AGENDA
Preservation Commission
Tuesday, October 8, 2024
Lorraine H. Morton Civic Center, Room 2800 7:00 PM

A. 24PRES-0134 - 711 Michigan Avenue - Lakeshore Historic District 4 - 25

B. 24PRES-0137 - 318 Greenleaf Street - Lakeshore Historic District 26 - 61

C. **24PRES-0138 - 2945 Central Street - Landmark**

2 PROPOSED SITE PLAN
HP-0 SCALE: 1" = 10' - 0"

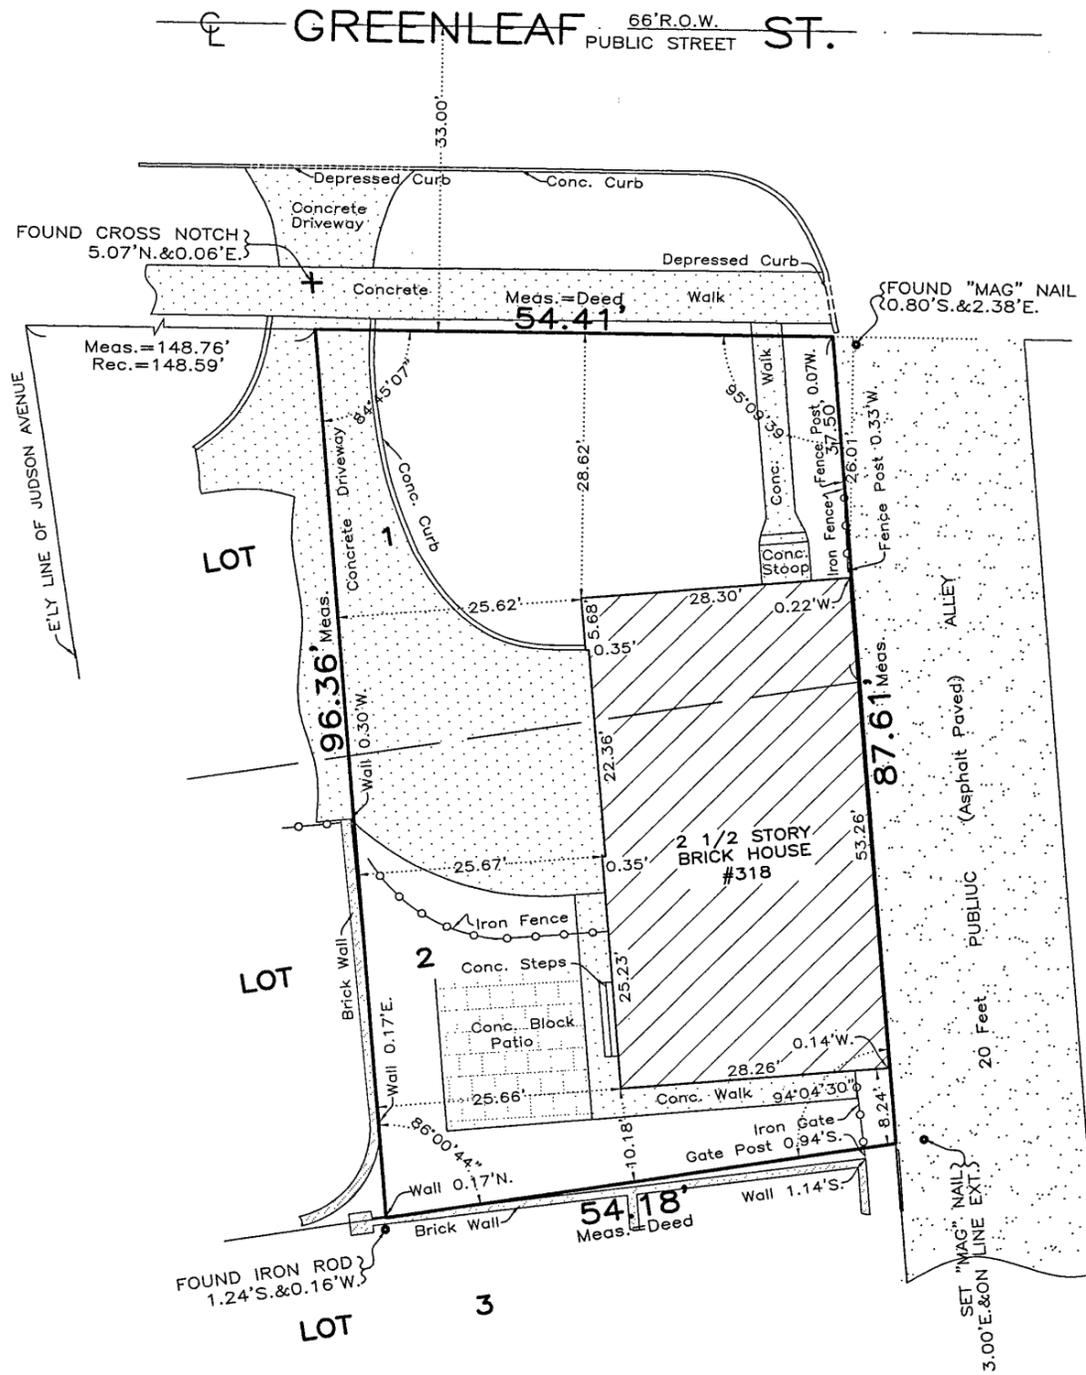
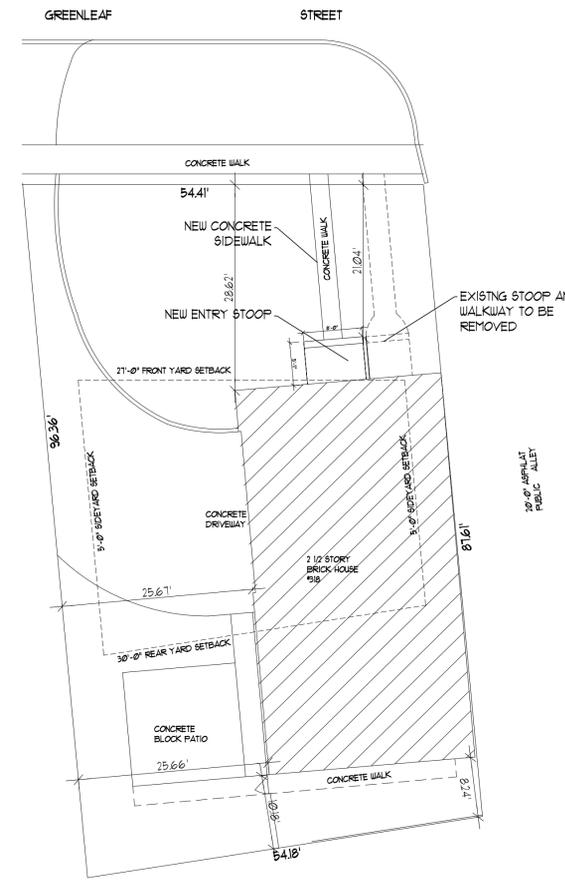
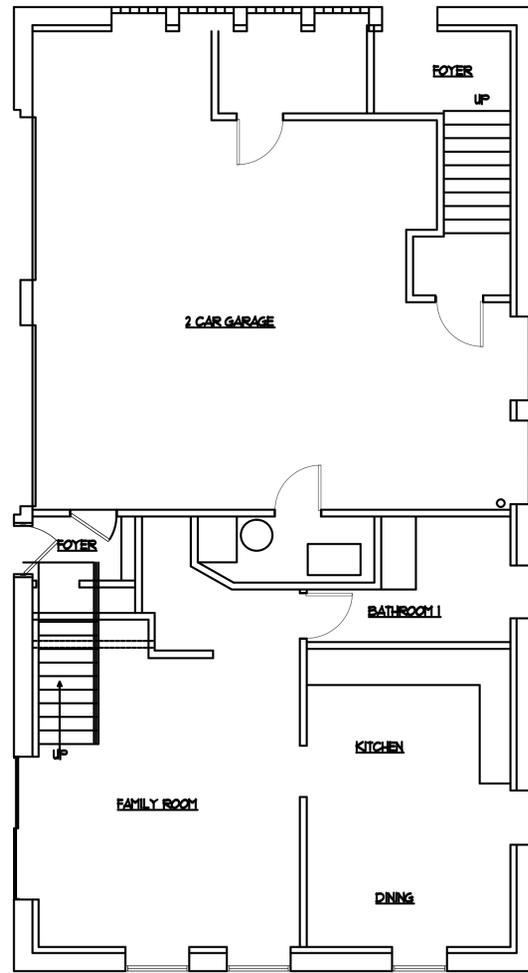
Code Section	Proposed and Required	Recommendation
6-8-2-7	Maximum permitted amount of building lot coverage is 30% of lot area, 1493.4 sf; 30.7%, 1530 sf proposed (30.3%, 1508 sf existing)	Apply for a major variation OR revise into compliance
6-8-2-12, 6-4-6-3, Table 4-B.19	Open parking is required to be located within 30' of the rear property line or alley; Open parking proposed in the west interior side yard more than 30' from the rear property line or alley.	Apply for a major variation, see comment #6.c below

- c. **Open parking location:** Proposed plan maintains 2 required off-street parking spaces with one space being an open parking pad located at the end of the existing driveway in a non-compliant location within the west interior side yard.

- i. Alternative: Remove the driveway within the west interior side yard while maintaining what is needed to maintain access for the property to the west. However, this option eliminates a required parking space triggering a variation to reduce required parking from 2 to 1.

2 PROPOSED ELEVATIONS
HP-3 SCALE: 1/4" = 1' - 0"

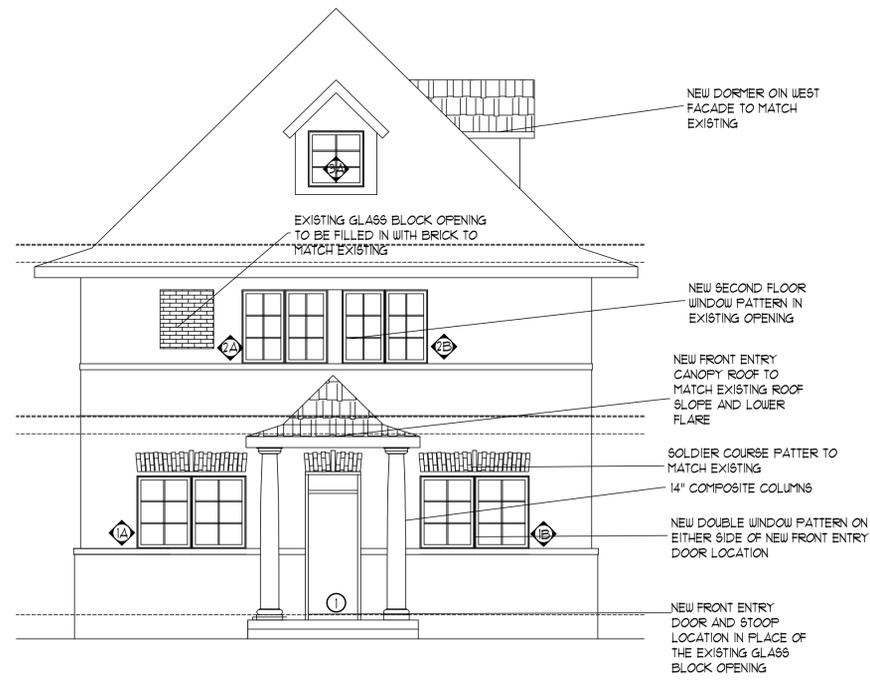
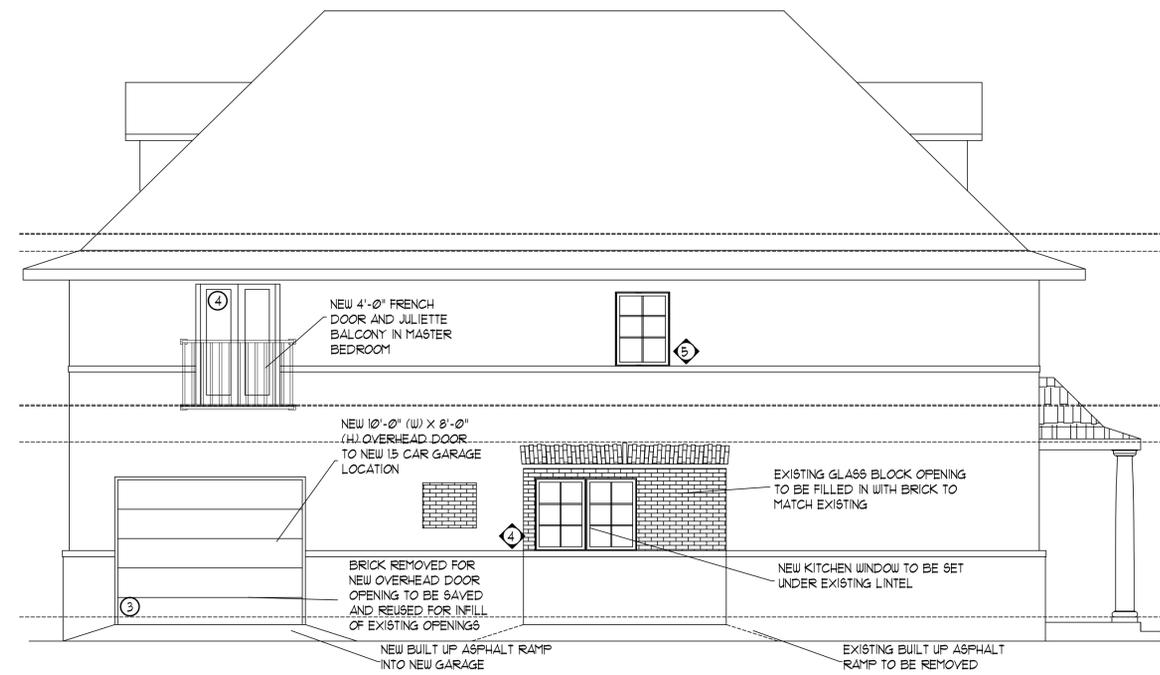
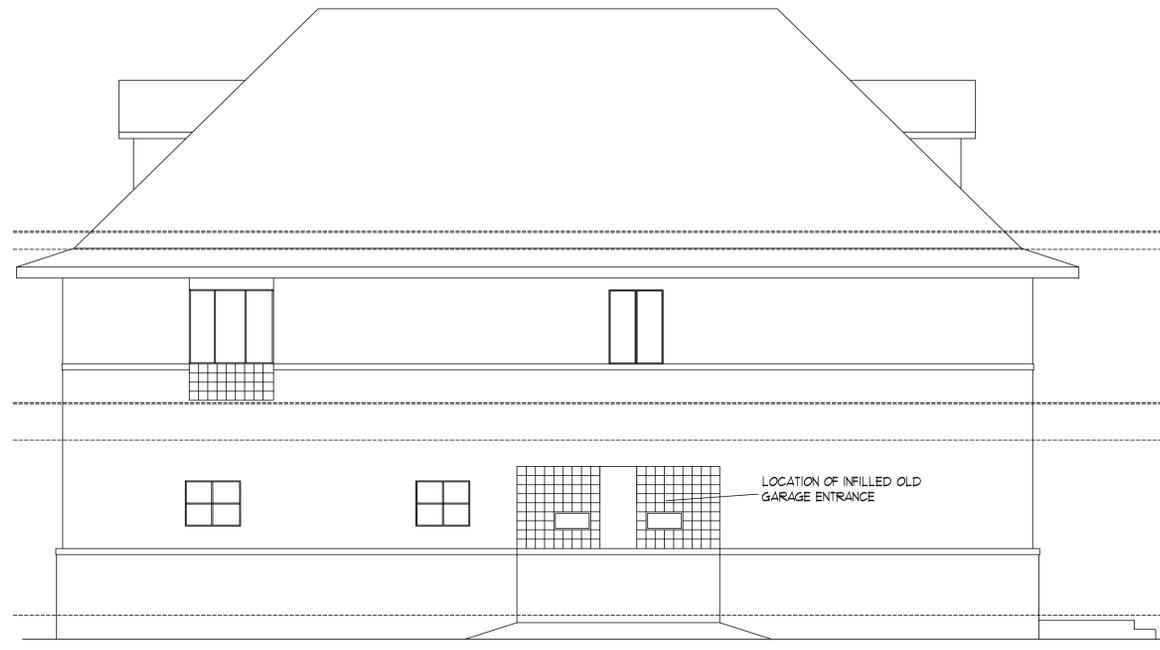
3. **Right-of-way review:**
- a. Proposed plan includes a Juliette balcony on the east elevation extending over and into the public alley right-of-way as well as altering the alley grade.

1 SITE PLAN
SCALE: 1/8" = 1'-0"

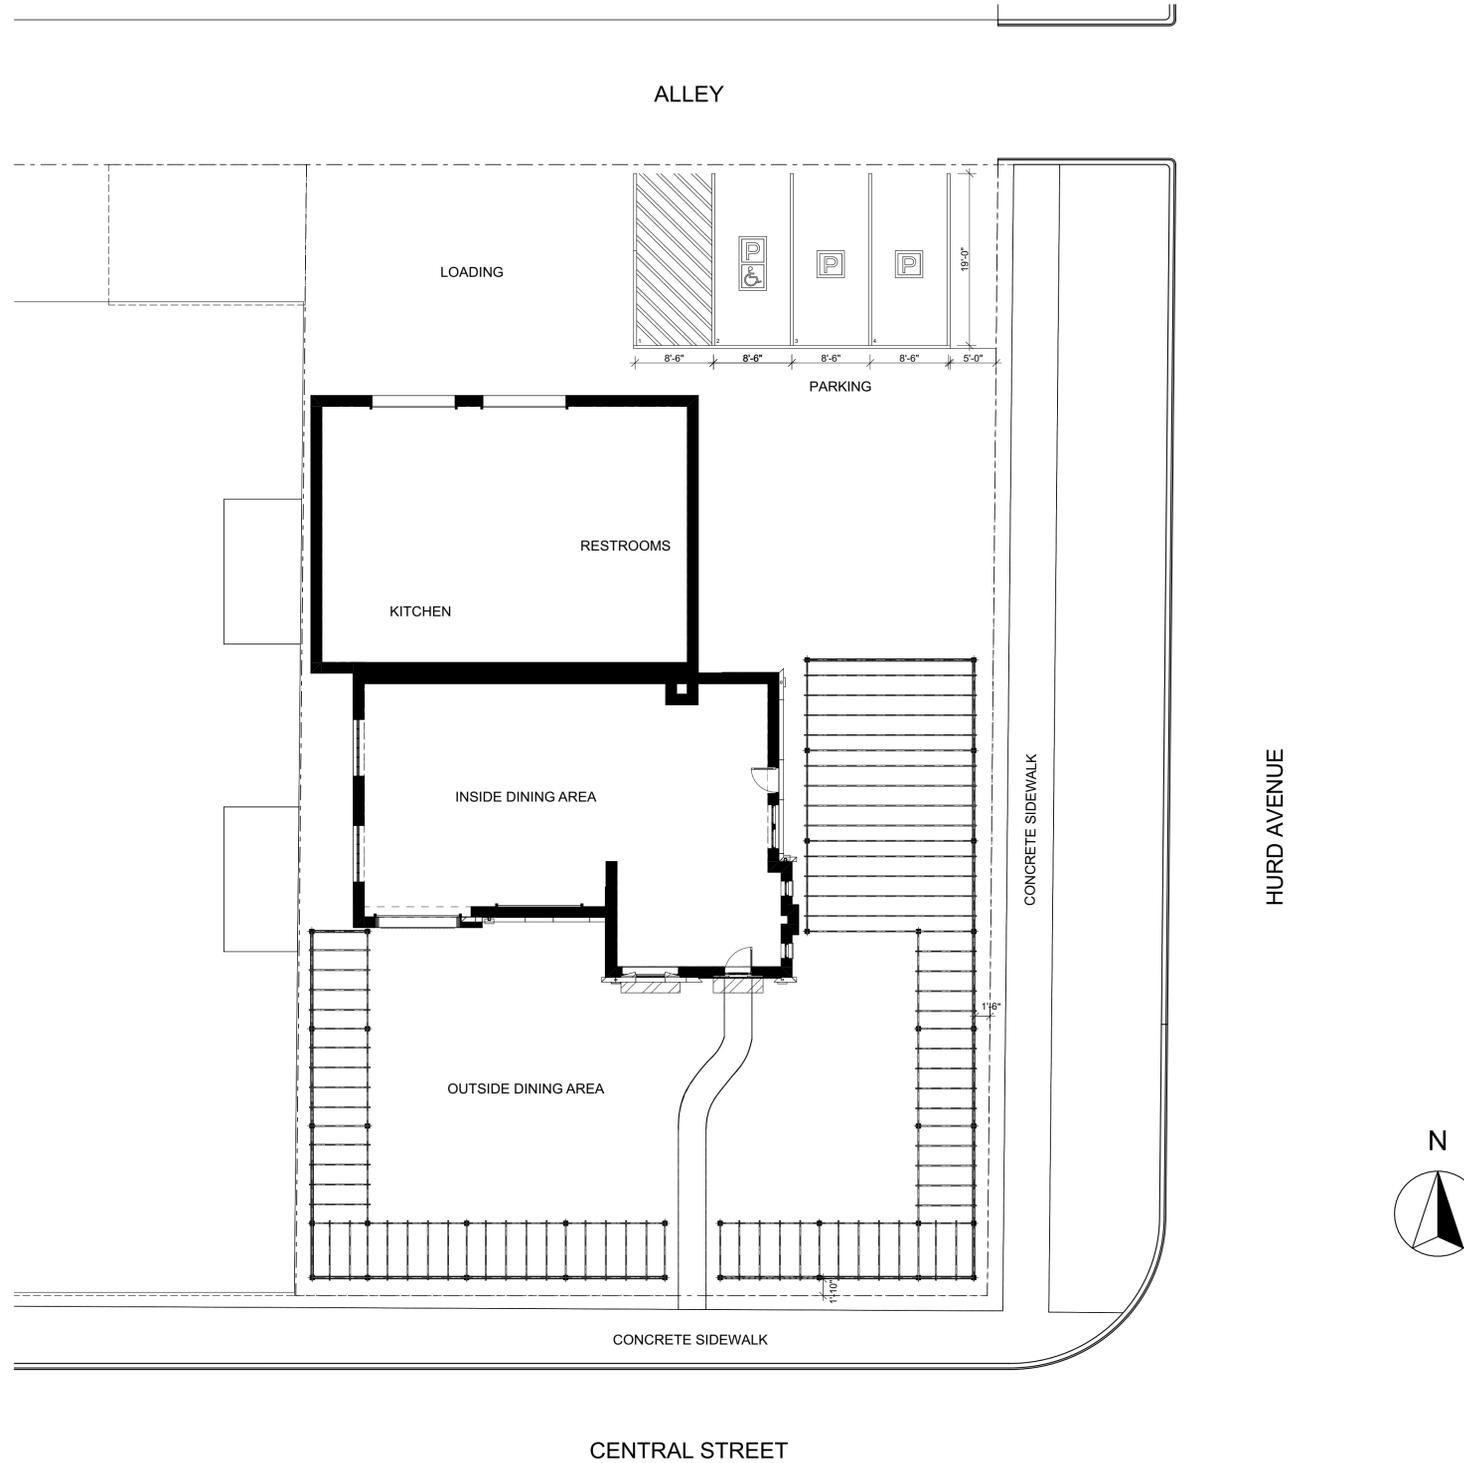
Code Section	Proposed and Required	Recommendation
6-4-6-7 (F) 2.(a)	Proposed fence in the front-yard where fences are only permitted in the front-yard when adjacent to a Type-1 Street (Central is not).	Application for minor variation
6-4-6-3 (A) 2.	Proposed accessory structure (arbor/pergola) within the front and street side-yards where they are only permitted within the rear-yard.	Application for minor variation
6-16-2-6	One accessible space where none are proposed	Revise plans to show required accessible space and aisle (16'W (8' for parking and 8' for accessible aisle) x 18' D)
